## ADDENDUM NO. 2

**TO: PLANS AND SPECIFICATIONS FOR STATE OF MISSOURI**

**State of Missouri St. Clair Readiness Center  
375 Commercial Avenue  
St. Clair Missouri 63077  
Project No. T2326-01**

SHEET TITLE:  
**FLOOR DEMO PLAN**

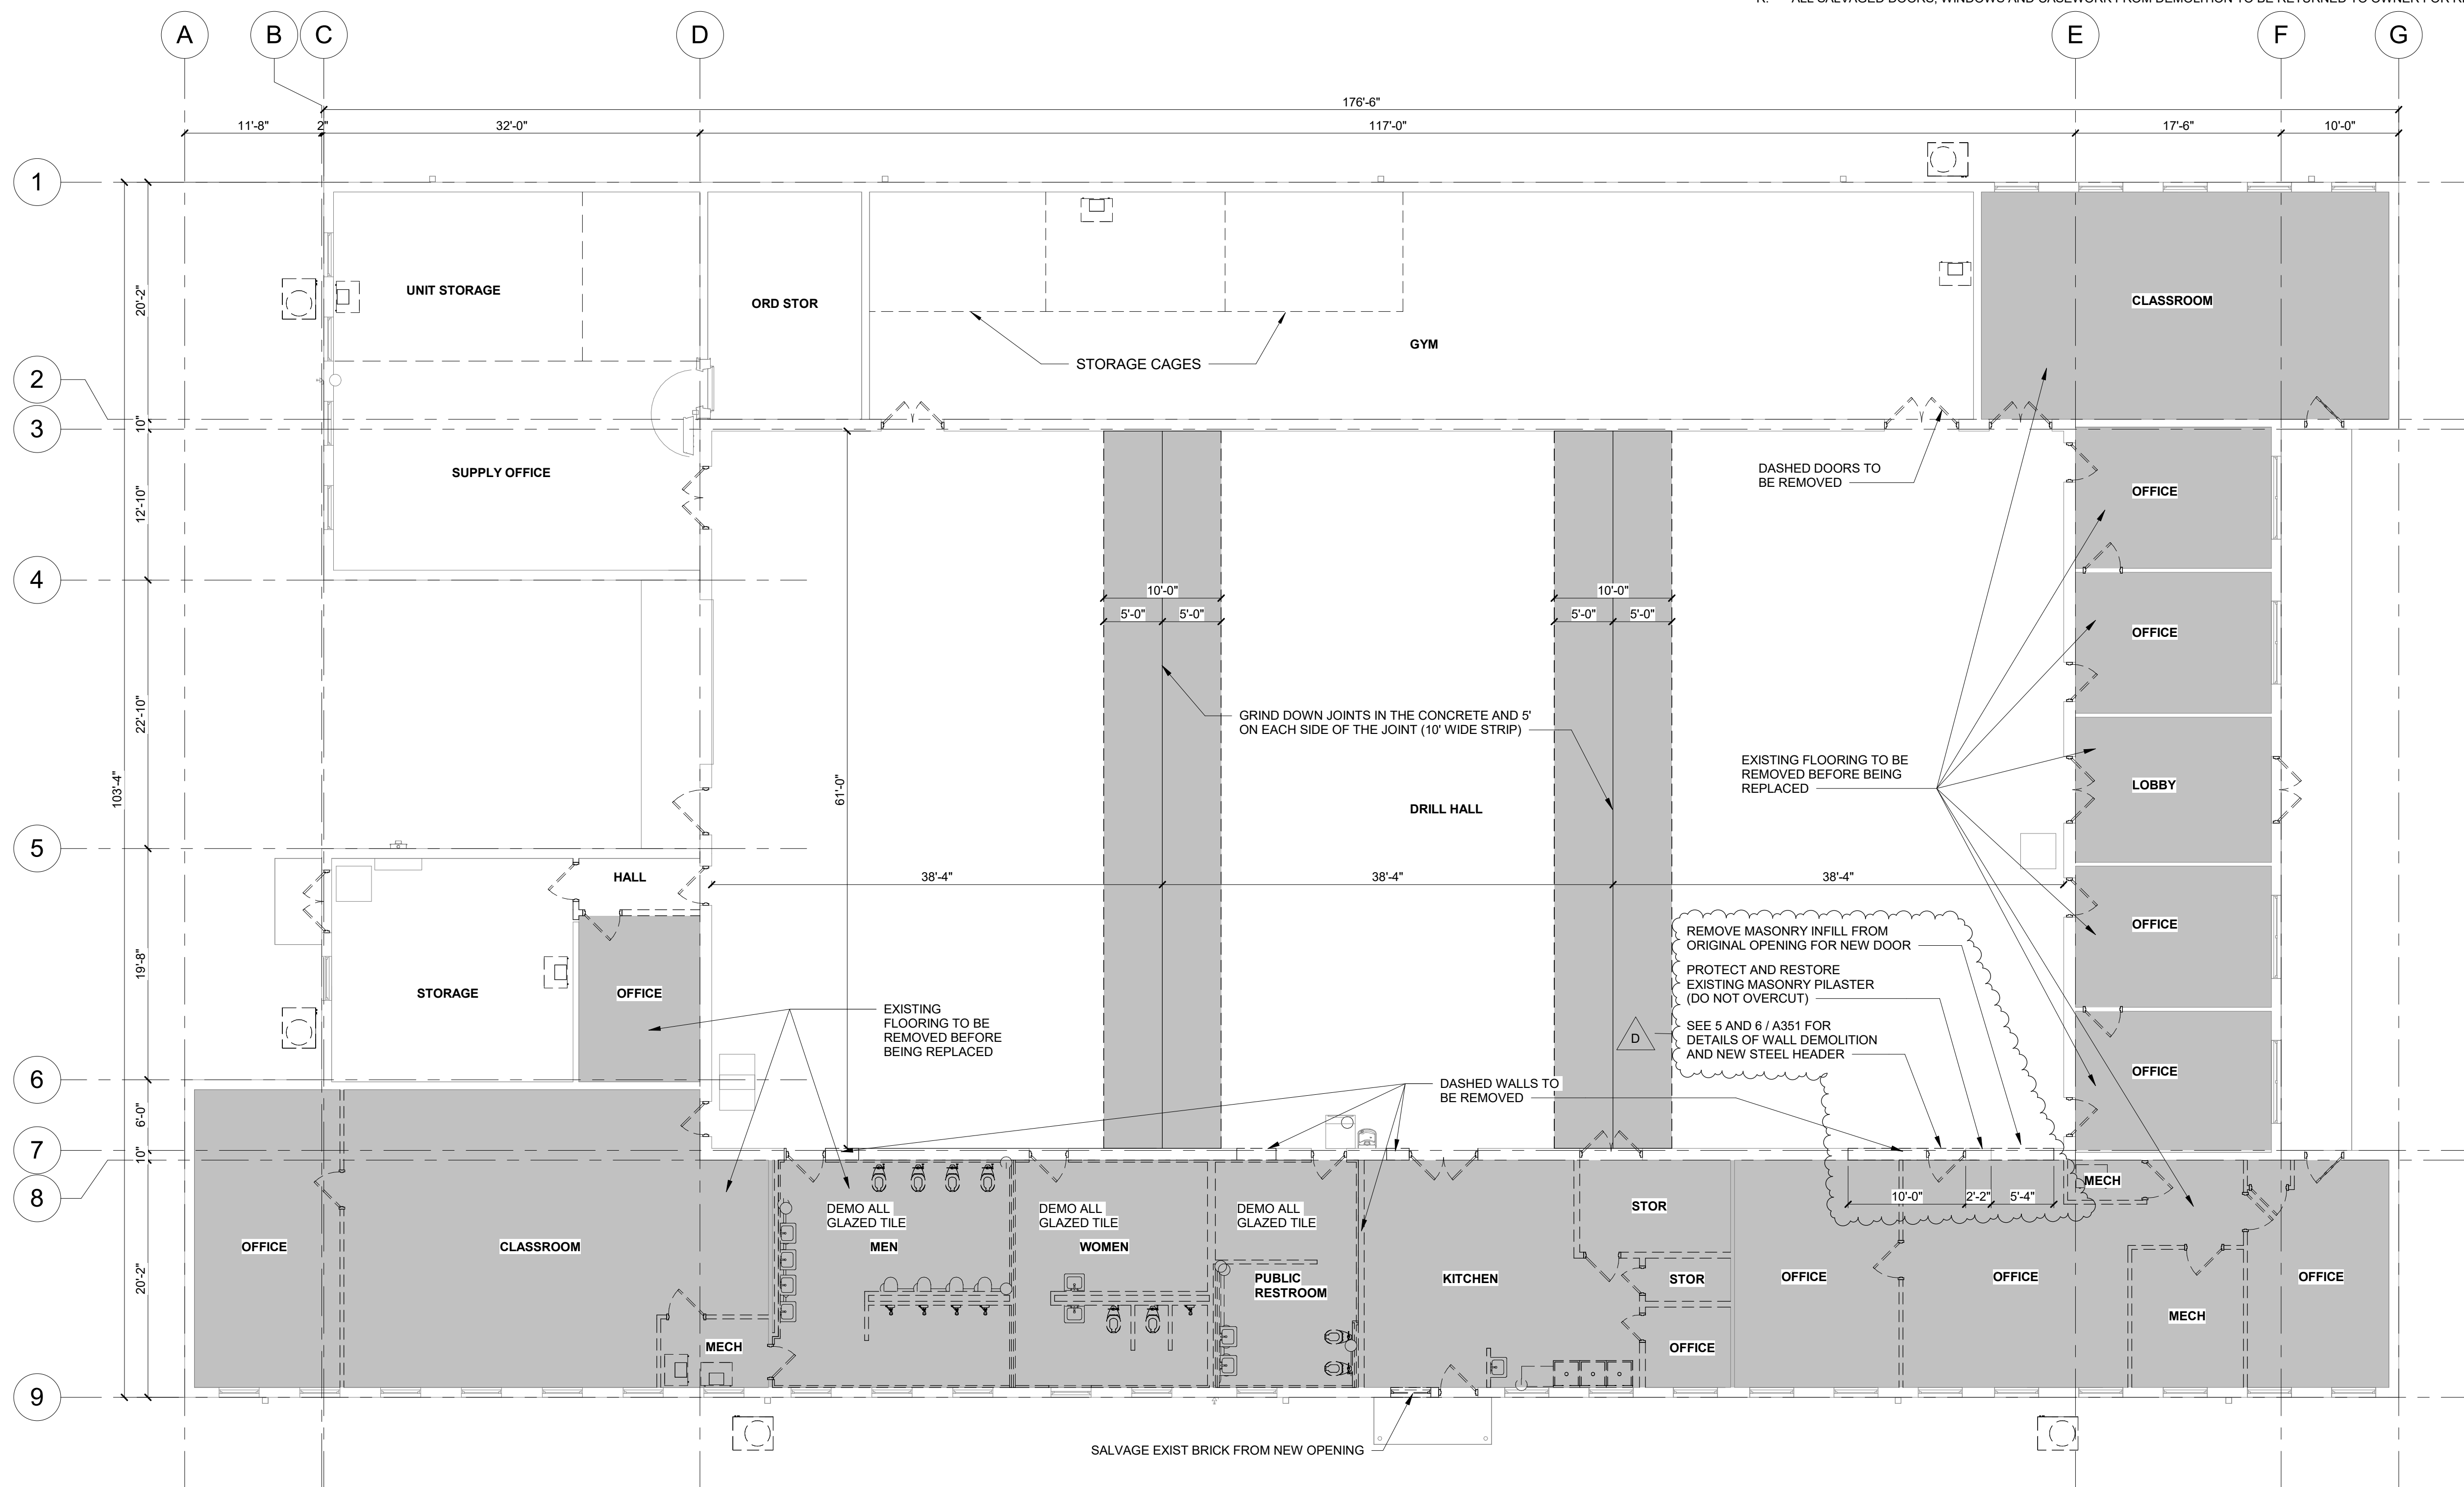
1. Drawing G001:
  - a. *CHANGE Revision number on architectural sheets.*
2. Drawing D101:
  - a. *ADD Callout for the counter opening in the kitchen*

**A100**

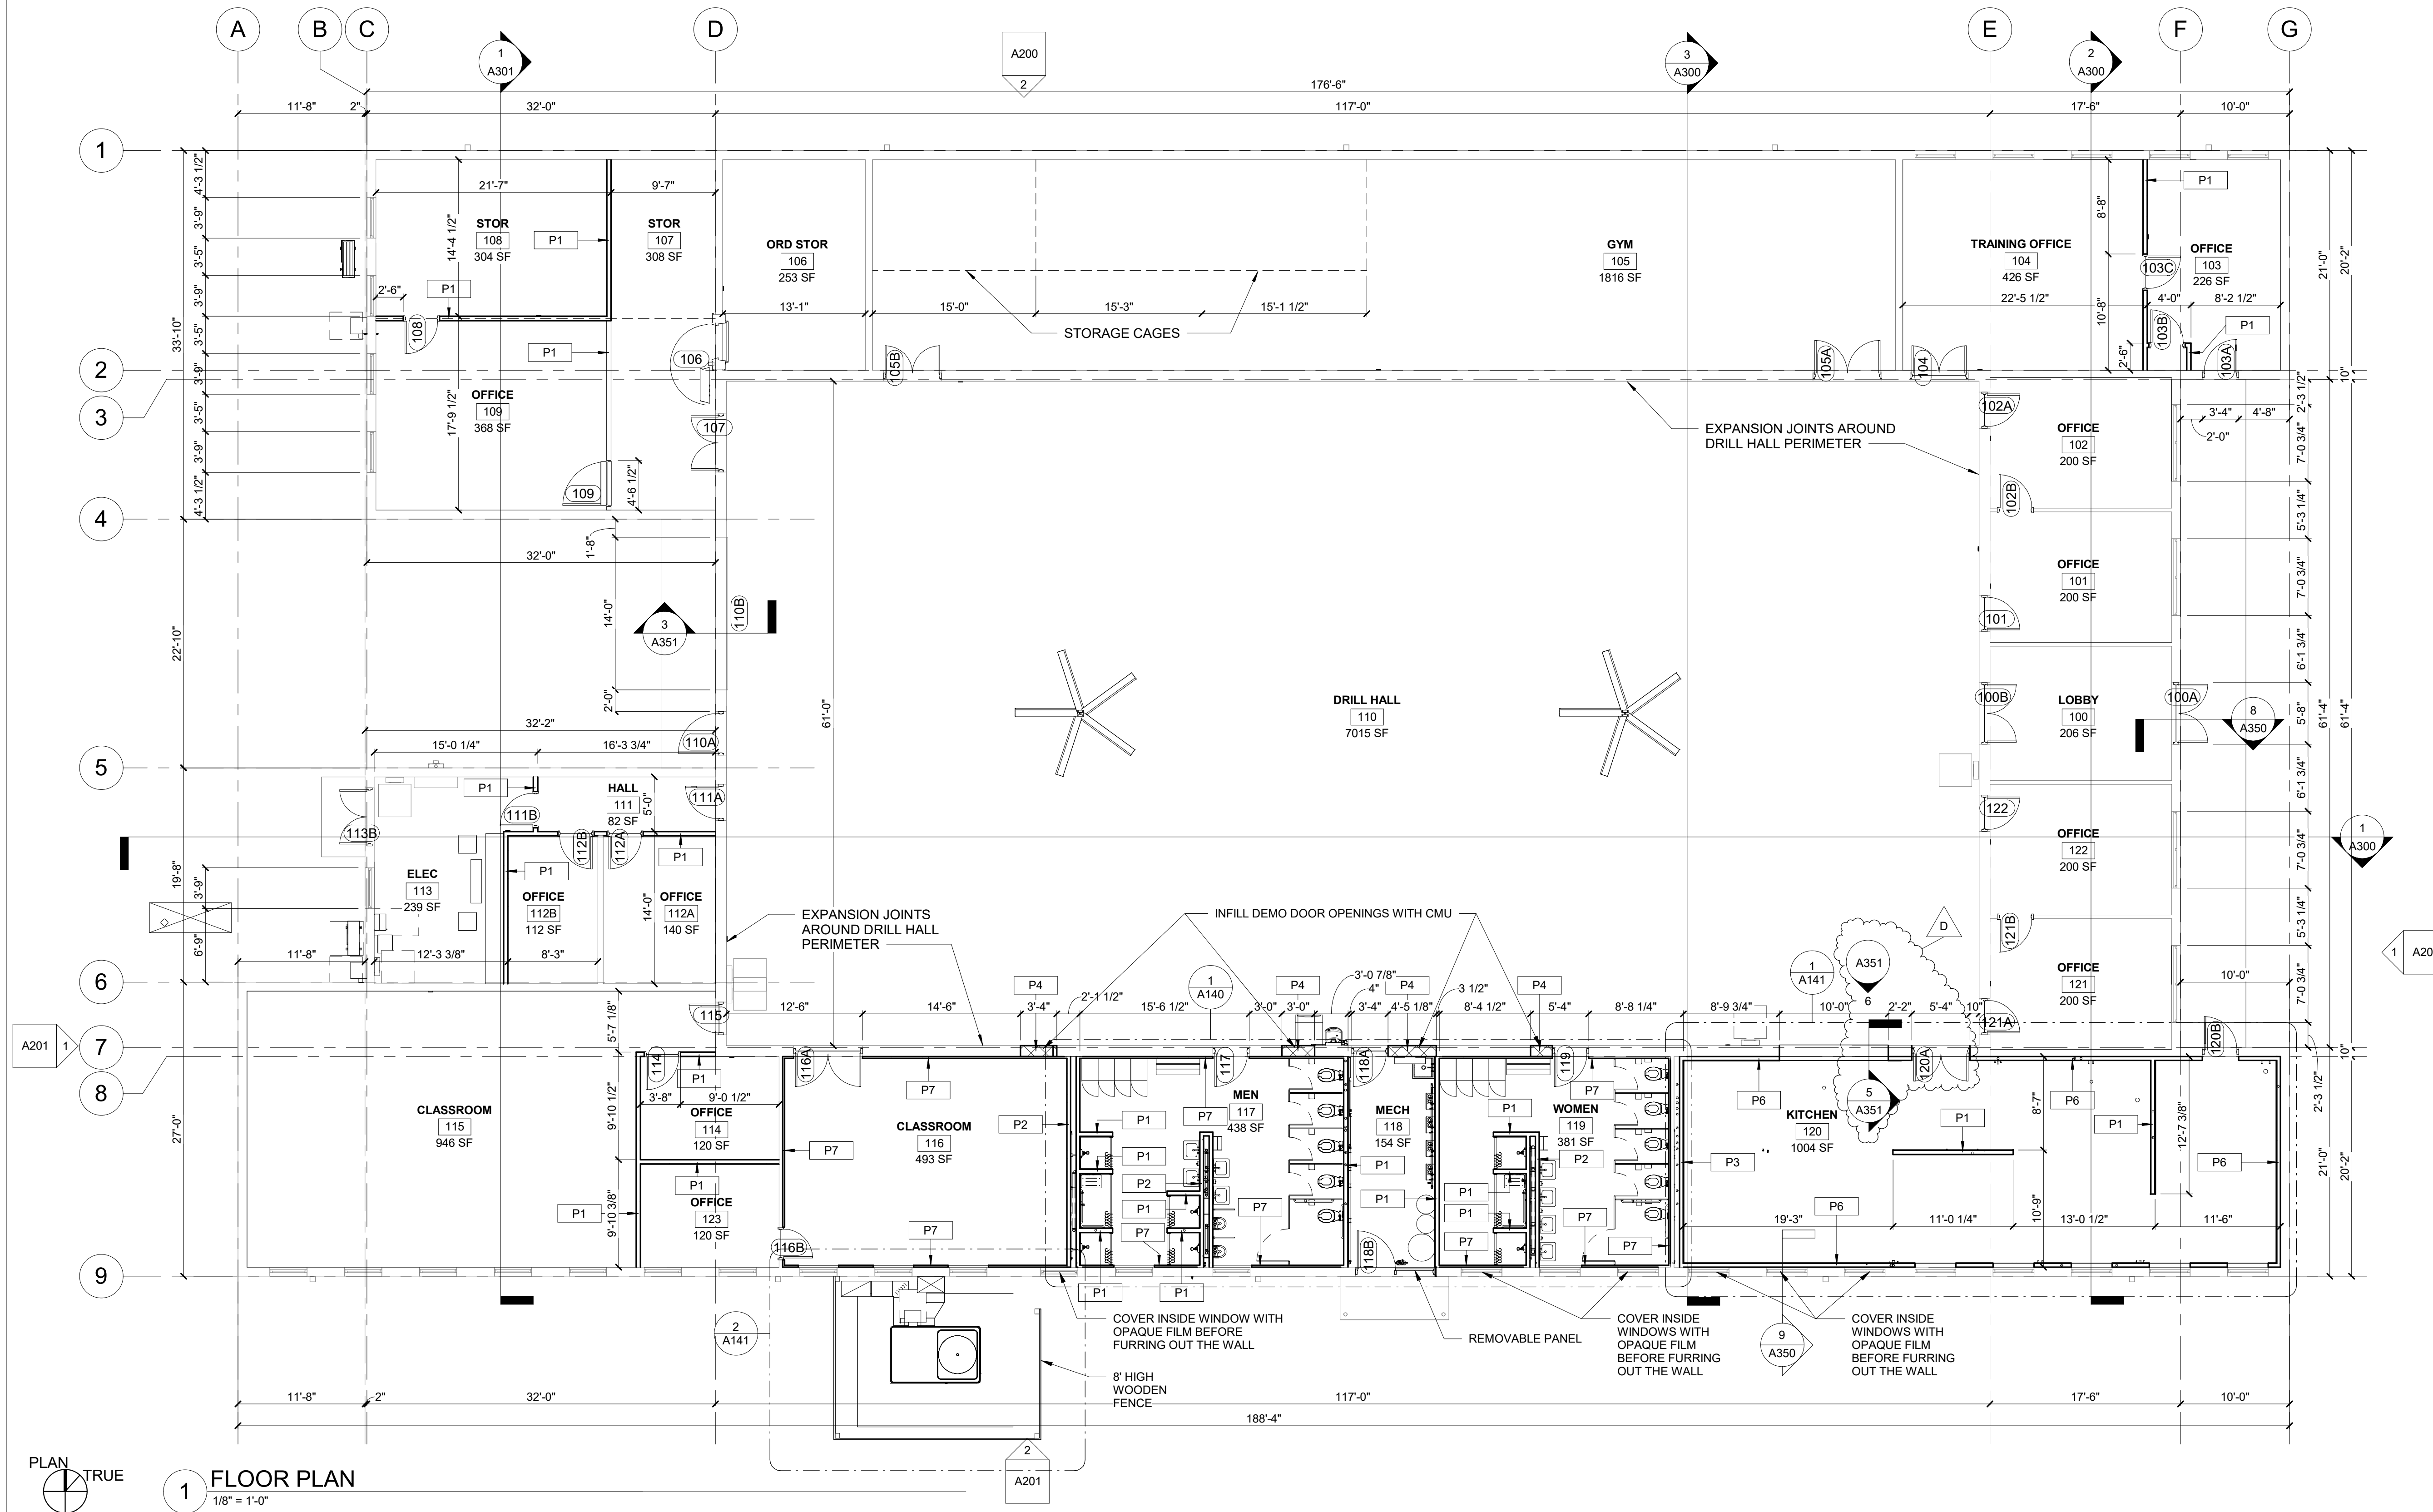
3. Drawing A100:
  - a. CHANGE Door 120A size.
4. Drawing A120:
  - a. Graphics changed from 2x4 to 2x2 ceiling tiles.
5. Drawing A140:
  - a. UPDATE Restroom accessories schedule, to clarify restroom accessories to be contractor furnished, contractor installed. The only items that will be owner furnished and contractor install will be the Paper Towel dispensers and soap dispensers
